Crumhach Wind Farm

Planning observation

Case reference: PAX21.324561
Applicant: SSE Renewables (Ireland) Limited
Development: Crumhach Wind Farm, County Sligo

Applicant’s drawing WCH-CVL-SK-0011-05, Rev. 01, 7 July 2026, sheet 005 of 007; Appendix 15-3, PDF page 36. [5]

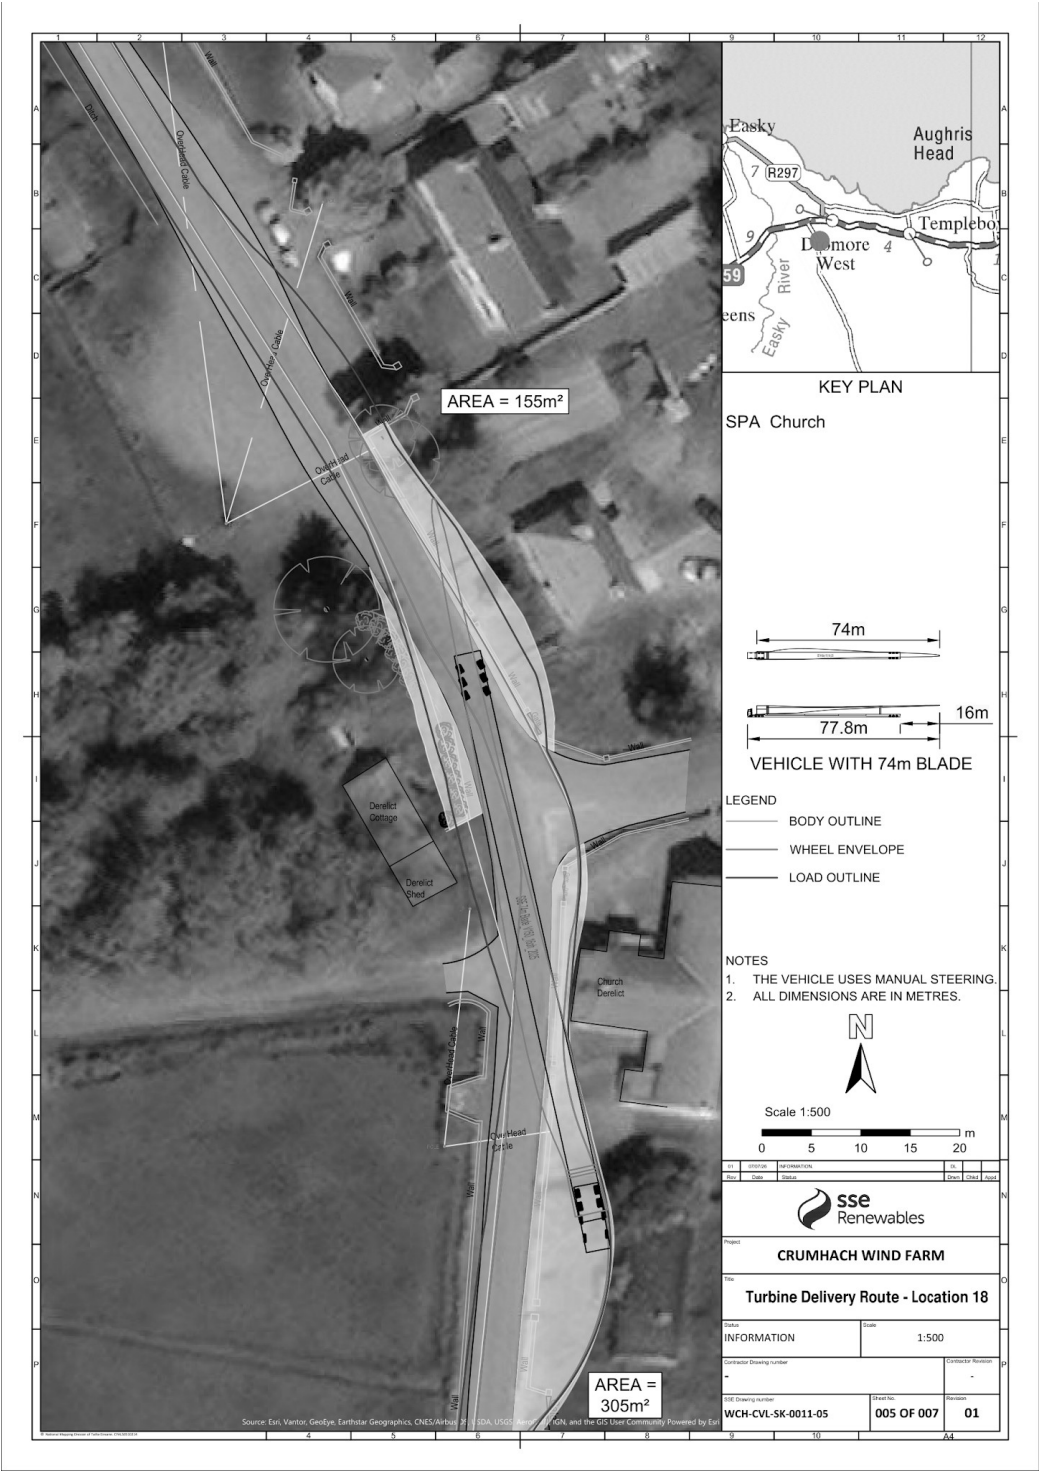
Drawing WCH-CVL-SK-0011-05 shows a delivery vehicle negotiating Location 18 on the L2702 beside the derelict church, using manual steering with a 74-metre blade. The drawing identifies nearby buildings, overhead cables and areas marked 155 m² and 305 m². These features demonstrate the constrained setting for the proposed manoeuvre. [4–5]

EIAR Chapter 15, Material Assets, section 15.1.9, p. 15-66 (Location 18), expressly identifies removal of a private wall and vegetation and preparation of a temporary run-over area for axle loads on private land east of the L2702. The corresponding route plan is Appendix 15-3, drawing WCH-CVL-SK-0011-05, Rev. 01, PDF p. 36. The manoeuvre depends on works beyond the carriageway, not simply the passage of a large vehicle. [4–5]

The application identifies the broad works, but the material cited here does not provide a sufficiently clear account of the precise extent of wall removal, how the works would be carried out and the final reinstatement at this bend. The swept-path drawing shows horizontal vehicle movement; it does not, by itself, establish construction methods, safe overhead clearance, ground strength or protection for adjacent property. The objection concerns the adequacy of the information, rather than an assertion that no works are described. [4–5]

The proposed run-over area makes ground strength, road edges, culverts and drainage particularly relevant. A vehicle tracking line does not demonstrate that each supporting surface can safely carry the loads.

Pre- and post-construction condition surveys can identify damage, but they do not prevent it. The proximity of the church, roadside masonry and overhead services makes protection during the works and deliveries a substantive concern. [4–6]

Turn 18 drawing note 1 expressly states that the vehicle uses manual steering. The plotted path therefore depends on the steering manoeuvre being achieved in practice. Allowance for variation in vehicle position, steering timing and the manoeuvre is material where the load passes walls, buildings and roadside obstacles. The drawing does not quantify a clearance buffer for these variations. Manual steering is not itself evidence that the turn is unsafe, but a plotted fit alone does not demonstrate a safe operating margin. [5, PDF p. 36]

The delivery vehicle configuration must be reconciled across the drawings, with minimum clearances and a justified safety buffer shown at Turn 18. The assessment should explain how manual steering will be controlled and how the operating area and safety cordon will be maintained during the manoeuvre. [5]

Location 13 — extract from drawing notes, PDF p. 30. All extracts are monochrome reproductions; no dimensions have been altered. Refer to the original drawings for full context.

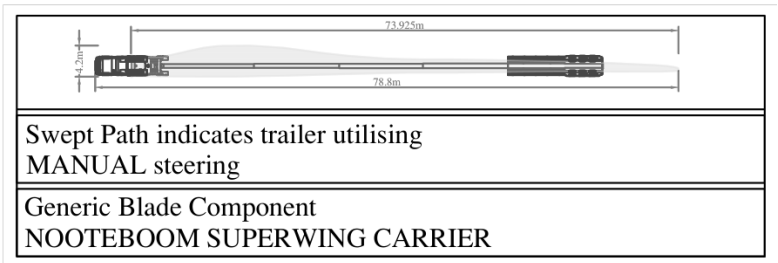
Appendix 15-3 shows an overall vehicle/load length of 78.8 m at Location 13, Ballysadare bridge (PDF p. 30), but 77.8 m at Location 14, Abbeystown (p. 32), and Location 18, the church bend (p. 36). The earlier model uses a generic Nooteboom carrier and a 73.925 m blade; the later model specifies a 74 m blade. The one metre difference therefore concerns the overall combination, rather than a shorter blade. [5]

The Location 13 notes state that an additional buffer is required outside the swept path and that no margin or safety cordon is included. These notes belong to the earlier drawing set. At Turn 18, the drawing identifies walls, buildings and overhead cables, but gives no labelled minimum obstacle-clearance distances or quantified operating margin. Its 155 m² and 305 m² labels are areas, not clearances. [5]

Foundation section from EIAR Chapter 4, Figure 4-5, PDF page 15. Cropped monochrome reproduction showing the tapered profile. Maximum width and depth do not establish the concrete volume. Do not scale from this image. [3]

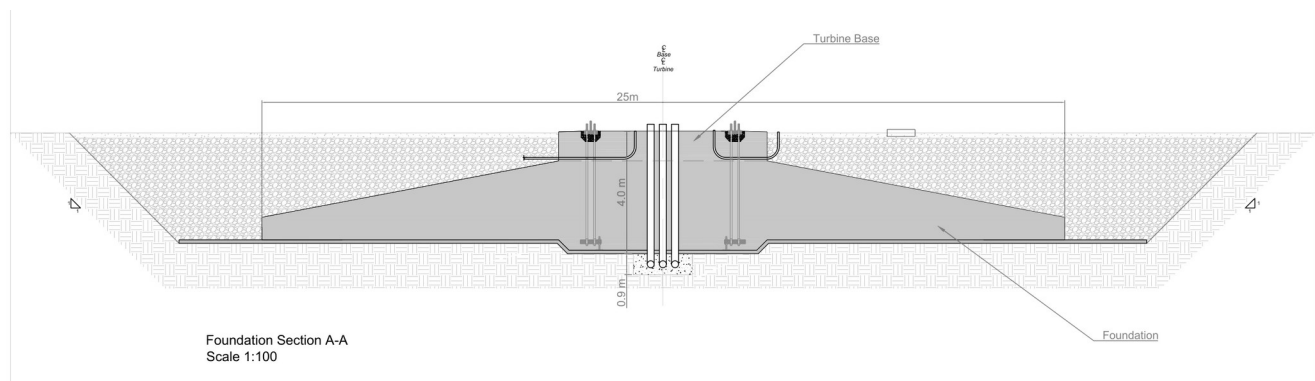
The objection includes frequent ready-mix concrete deliveries and their effect on local road users. The figures below come from the applicant's traffic assessment. Chapter 4 shows a tapered foundation; its maximum width and depth alone do not establish the concrete volume. [3–4]

The foundation assumptions are inconsistent across the EIAR. Chapter 4, section 4.8.2.3 (p. 4-88), says piled foundations are likely, with gravity foundations possible particularly at T4, T5 and T6. Chapter 8, section 8.6 (p. 8-36), instead expects gravity foundations at 12 turbines (T2 and T7–T17), with either option at the other five. The traffic assessment needs to demonstrate that its concrete allowance covers the foundation options assessed. [3 –4, 24]

The pile specifications also differ. Figure 4-6 shows 16 piles, each 18 m long and 1.2–1.6 m in diameter; Chapter 4, p. 4-88, describes a possible arrangement of up to 20 piles of 0.9 m diameter. For the largest piles in Figure 4-6, the cylindrical volume is $16 \times \pi \times 0.8^2 \times 18 = 579.1 \text{ m}^3$ per turbine, before the base above. These alternatives require a clear explanation of the quantities used in the traffic forecast. [3]

Why the allowance needs explanation: at 8 m³ per load, their 75 loads provide 600 m³ per turbine. The largest drawn piles alone require 579.1 m³, leaving $600 - 579.1 =$ only 20.9 m³ for the base above. This does not reconcile with the illustrated substantial base. Either the assumed lorry capacity, the foundation option, or the delivery allowance needs to be explained and supported by quantities.

Source: applicant EIA/IA Chapter 14, Figure 14-18, printed page 14-71 (PDF page 75), final 7 August 2026. Historic OS background with proposed works. Grayscale reproduction; original legend uses colours. Use the original drawing for engineering detail.

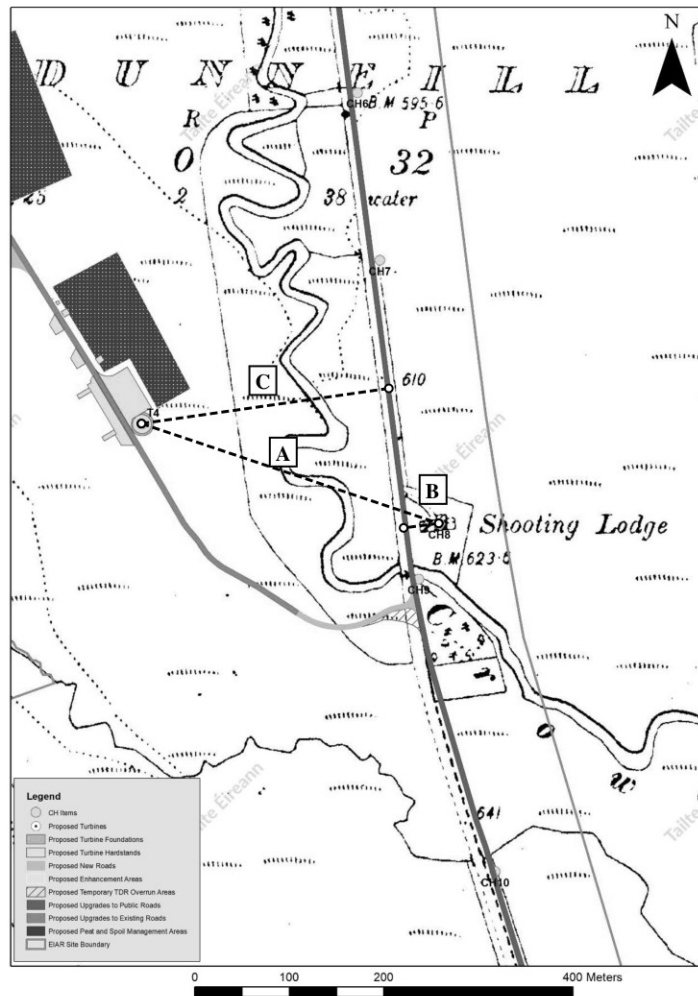
The applicant reports 332 m between lodge CH8 and T4. Section 5.8 of the 2006 Guidelines advises separation from national and regional roads and railways equal to full turbine height, or 176.6–180 m for this proposal. The December 2019 draft proposes height plus 10%, or 194.3–198 m. These figures cannot establish a breach here without the relevant road classification and surveyed measurements. The principal visual objection is the acknowledged significant effect and the unclear coverage of the views around the lodge. [2,9–10]

A Lodge CH8 to turbine T4
332 m reported by the applicant
Table 14-10, Chapter 14.

B Lodge CH8 marker to public-road line
Approximately 40 m
Indicative measurement from the figure.
This is not a surveyed wall-to-road-edge clearance.

C T4 marker to public-road line
Approximately 260 m
Indicative nearest separation on this figure; not a surveyed road-boundary distance.
